**HISTON ROAD: BUS, CYCLING AND WALKING IMPROVEMENTS
FINAL DESIGN SUMMARY POINTS**

Post Consultation Changes and Reasons

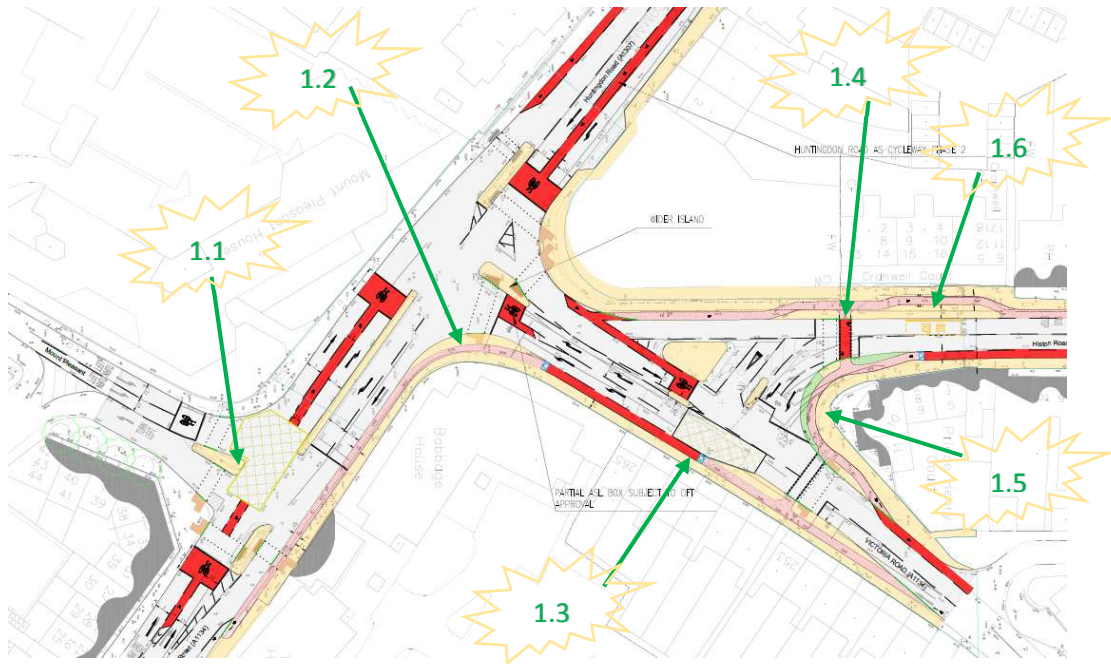
1.1 Island trimmed back.

Reason – Road safety and Signals officers suggested that it would be beneficial to create more space for Vehicles and Cycles to pass through this constrained area.

1.2 Cycle lane placed on carriageway and controlled by traffic signal.

Reason – Road safety officers highlighted that the proposed segregated route around this corner created a dangerous conflict point between pedestrians and cyclists due to the lack of space and visibility.

1.3 Cycle lane controlled by traffic signal.

Reason – Road safety officers highlighted that uncontrolled cyclists entering the junction from Victoria Road would enter a zone of potential conflict with cyclists and overrunning vehicles turning right from Histon Road.

1.4 Pedestrian crossing moved away from the junction further up Histon Road..

Reason - Drivers looking to turn from Victoria Road into Histon Road will be looking over their left shoulder for a gap in traffic. Having the pedestrian crossing metres away from this uncontrolled turning point come with a high risk that these drivers do not notice the crossing in time.

1.5 On carriageway cycle lane added. Off carriageway provision for cyclists retained but as shared used

Reason – Discussion during consultations and subsequently with Cycling Project Officers highlighted that many cyclist would be more likely to stay on road through this part of the junction especially given the diversionary nature of the off road proposals and the limited green time that would be afforded to the off carriageway route. A pragmatic decision was taken (which was supported by most at the LLF workshop on 8th October) that it would be better to therefore enhance the on road space for cyclists but still provide off road facilities for cyclists who were not confident to use the on road option but in the form of shared space – given the limitation in space resulting from adding the cycle lane on carriageway.

1.6 Re-instate Pay and Display layby, move outbound bus stop and crossing

Reason - Feedback from the consultation focussed on the importance of maintaining some pay and display parking at this end of Histon Road to support local business. Road safety officers also recommended moving the proposed pedestrian crossing further from the junction to enhance the visibility of the crossing signals to drivers turning into Histon Road from Victoria Road. They also recommended moving the bus stop further from the junction to avoid blocking.

This combined feedback has led to a re-design of how we allocate some of these requirements in this small area. The parking bays have been retained as has the small loading area for the supermarket on the inbound side of Histon Road (denoted by single yellow line and signage). The crossing and the outbound bus stop has been moved further from the junction. With this configuration, there is no space to safely include a new inbound bus stop, instead the current pairing with the inbound bus stop just around the corner on Victoria Road is maintained.

Histon/Victoria/Huntingdon Road Junction

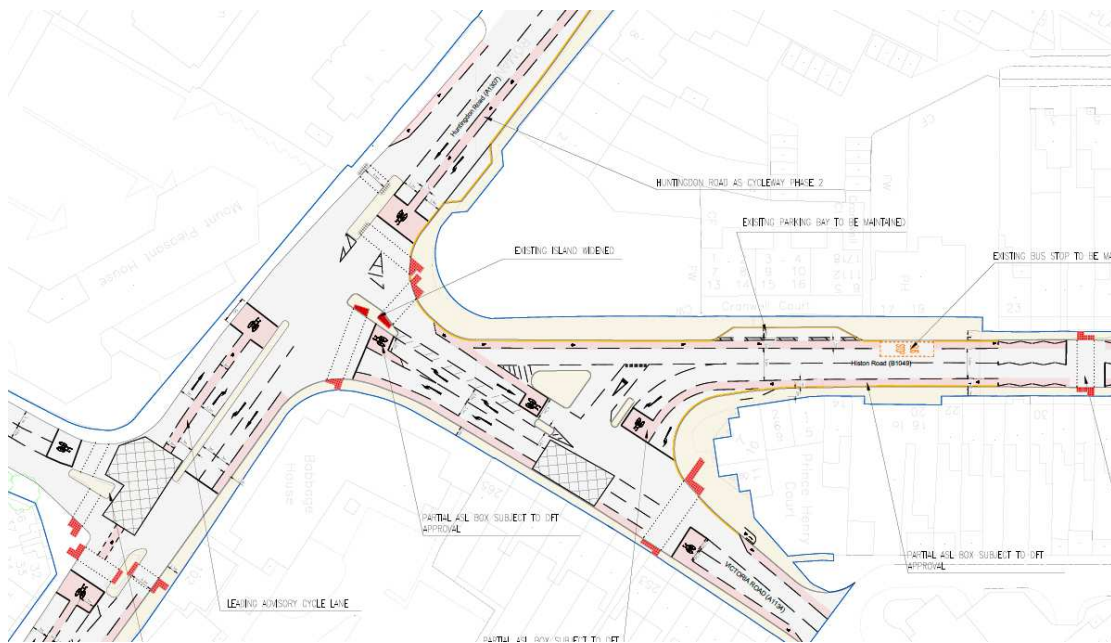
Pre consultation design with conflict points marked as highlighted by Road Safety

Post Consultation / LLF Workshop / Officer Review design with conflict points removed.

Histon/Gilbert/Warwick Road Junction

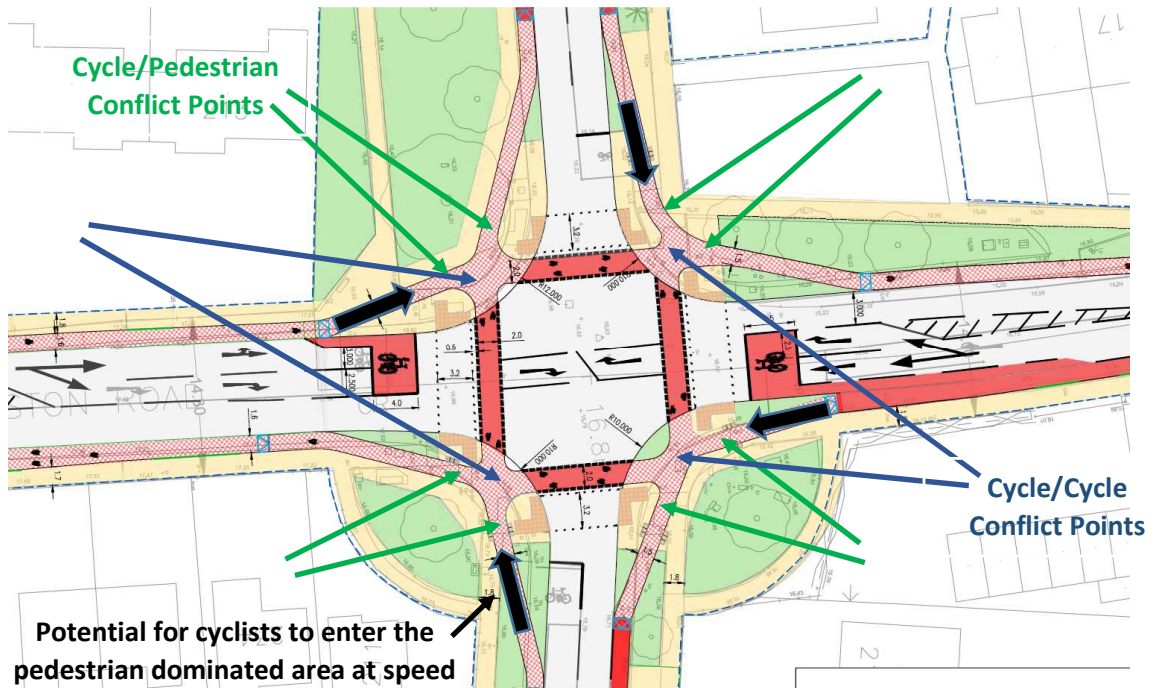
1.12 Redesign the off carriageway space at Histon Road/Gilbert Road/Warwick Road Junction and provide additional on carriageway space for cyclists.

Reason - The proposed junction design was strongly supported through the consultation process, although some concern was raised that slightly more width should be provided for cyclists using the on-road option though the junction. However, road safety, signals and cycling projects officers raised strong concerns around the potential conflict points between pedestrians and cyclists that were introduced by this design and recommended modifications to the design to improve functionality, flexibility, and in particular accessibility

- More space to on-road cyclists traversing the junction from North-South or visa versa.

- The cycle and pedestrian crossing have been switched around, this provides much larger area for pedestrians to wait, and it also reduces the number of potential conflict points around the junction and allows us to place mini zebra crossings to ensure pedestrian priority.

- The repositioning of the cycle crossing also provides a steeper exit from carriageway to off carriageway areas which should have the effect of slowing cyclists entering this area.

Pre consultation design with conflict points marked as highlighted by Road Safety

Post Consultation / LLF Workshop / Officer Review design with conflict points removed.

Simpler arrangement for Pedestrians, especially those who are visually impaired and who rely on the tactile paving
